SUNDRY NOTICES AND REPORTS ON WELLS (DO NOT USE THIS FORM FOR PROPOSALS TO DRILL OR TO DEEPEN OR PLUG BACK TO A DIFFERENT RESERVOIR. USE "APPLICATION FOR PERMIT" (FORM C-101) FOR SUCH PROPOSALS.)		WELL API NO. 30-015-48313
1. Type of Well: Oil Well ☒ Gas Well ☐ Other ☐		5. Indicate Type of Lease STATE ☒ FEE ☐
2. Name of Operator EOG Resources, Inc.		6. State Oil & Gas Lease No. 322721
3. Address of Operator P.O. Box 2267, Midland, Texas 79702		7. Lease Name or Unit Agreement Name Golden Graham 1 State Com
4. Well Location Unit Letter <u>N</u> : <u>215</u> feet from the <u>South</u> line and <u>1784</u> feet from the West line Section <u>1</u> <u>26S</u> Township <u>28E</u> Range <u>NMNM</u> Eddy County		8. Well Number 702H
11. Elevation (Show whether DR, RKB, RT, GR, etc.) 2933' GR		9. OGRID Number 7377
		10. Pool name or Wildcat 98220 Purple Sage; Wolfcamp (Gas)

EOG respectfully requests an amendment to our approved APD for this well to reflect the following changes:

Update casing and cement program to current design.

Golden Graham 1 State Com #702H

Golden Graham 1 State Com #702H
Eddy County, New Mexico
Proposed Wellbore
Design B

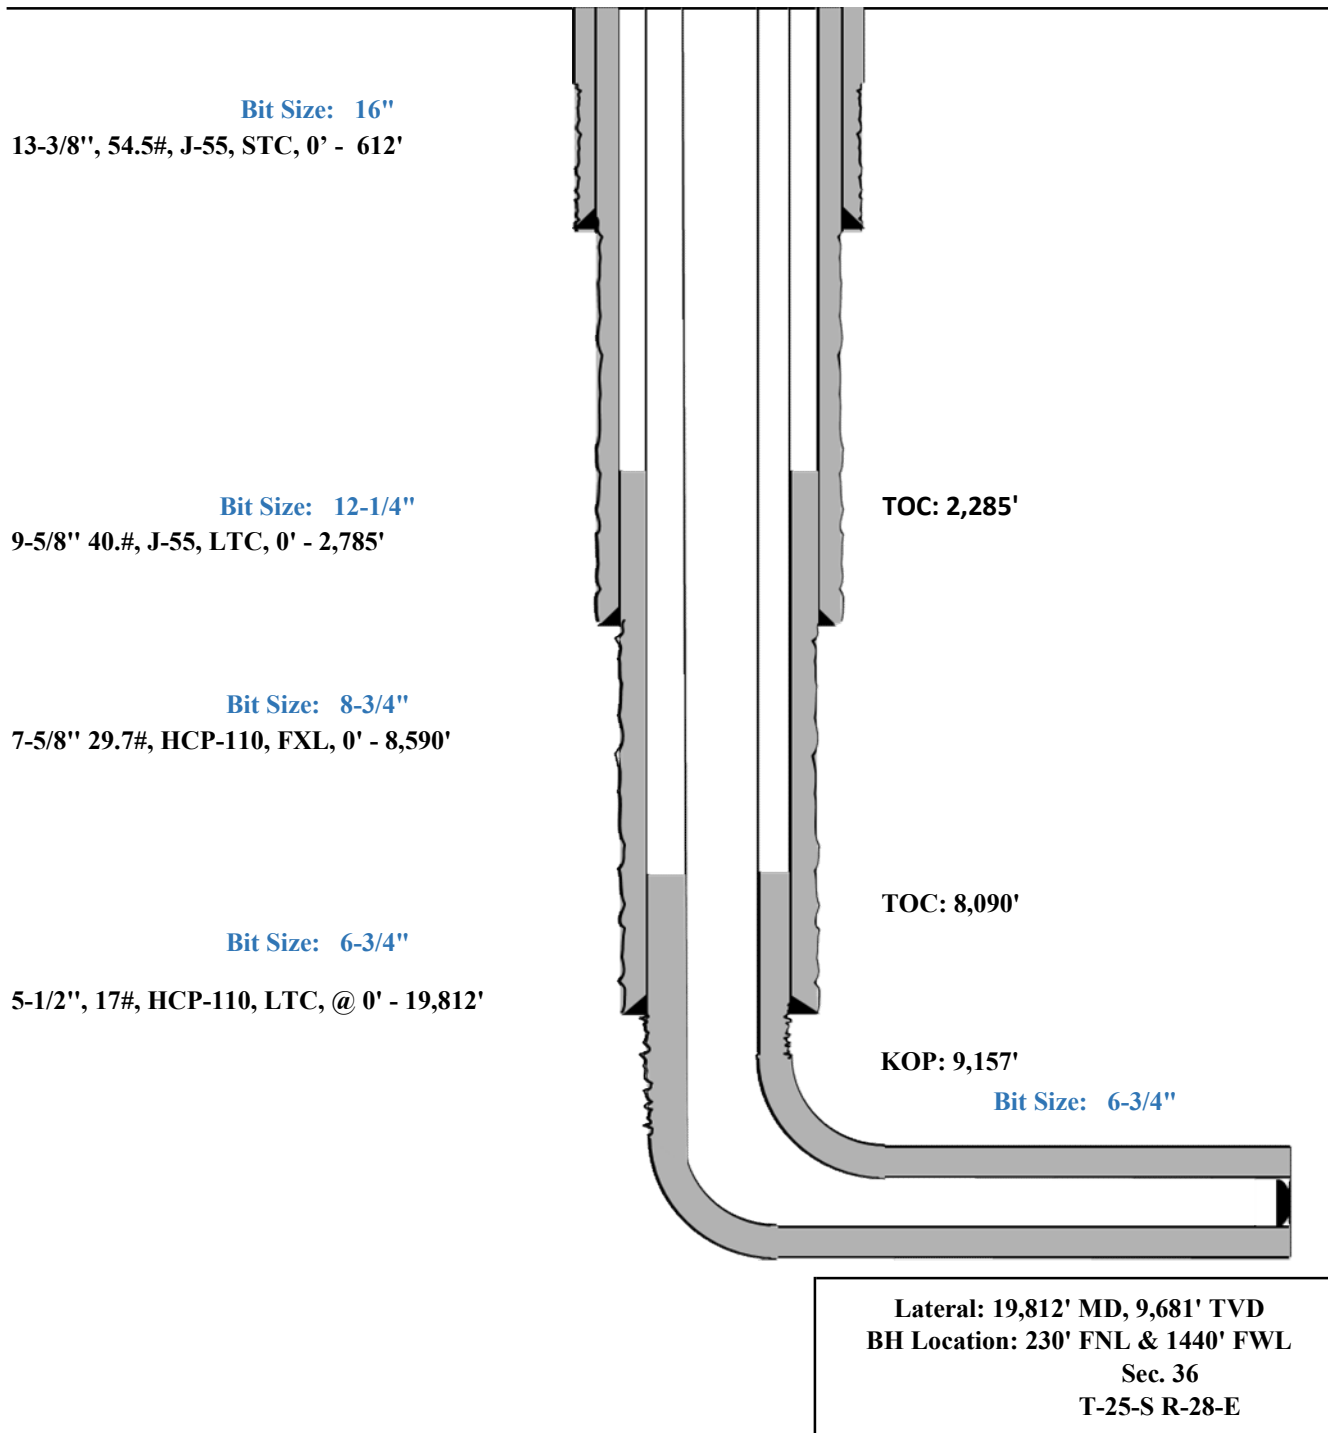
As a contingency, EOG requests to pump a two stage cement job on the 7-5/8" intermediate casing string with the first stage being pumped conventionally with the calculated top of cement at the Brushy Canyon (4,800') and the second stage performed as a bradenhead squeeze with planned cement from the Brushy Canyon to surface. If necessary, a top out consisting of 1,000 sacks of Class C cement + 3% Salt + 1% PreMag-M + 6% Bentonite Gel (1.5 yld, 14.8 ppg) will be executed.

Hole Size	Interval	Csg OD	Weight	Grade	Conn	DFmin Collapse	DFmin Burst	DFmin Tension
16"	0' - 612'	13.375"	54.5#	J-55	STC	1.125	1.25	1.6
12.25"	0' - 2,785'	9.625"	40#	J-55	LTC	1.125	1.25	1.6
8.75"	0' - 8,590'	7.625"	29.7#	HCP-110	FXL	1.125	1.25	1.6
6.75"	0' - 19,812'	5.5"	17#	HCP-110	FXL	1.125	1.25	1.6

Depth	No. Sacks	Wt. ppg	Yld Ft3/sk	Slurry Description
612'	180	13.5	1.73	Lead: Class C + 4.0% Bentonite Gel + 2.0% CaCl ₂ (TOC @ Surface)
	100	14.8	1.34	Tail: Class C + 0.6% FL-62 + 0.25 lb/sk Cello-Flake + 0.2% Sodium Metasilicate + 2.0% KCl (1.06 lb/sk)
2,785'	410	12.7	2.22	Lead: Class C + 0.15% C-20 + 11.63 pps Salt + 0.1% C-51 + 0.75% C-41P (TOC @ Surface)
	190	10.8	1.32	Tail: Class C + 0.13% C-20
8,590'	180	14.8	3.67	Lead: Class H + 0.40% D013 + 0.20% D046 + 0.10% D065 + 0.20% D167 (TOC @ 2,290')
	100	14.8	2.38	Tail: Class H + 94.0 pps D909 + 0.25% D065 + 0.30% D167 + 0.02% D208 + 0.15% D800 (TOC @ 7,086')
19,812'	1000	14.8	1.31	Class H + 0.1% C-20 + 0.05% CSA-1000 + 0.20% C-49 + 0.40% C-17 (TOC @ 8,086')
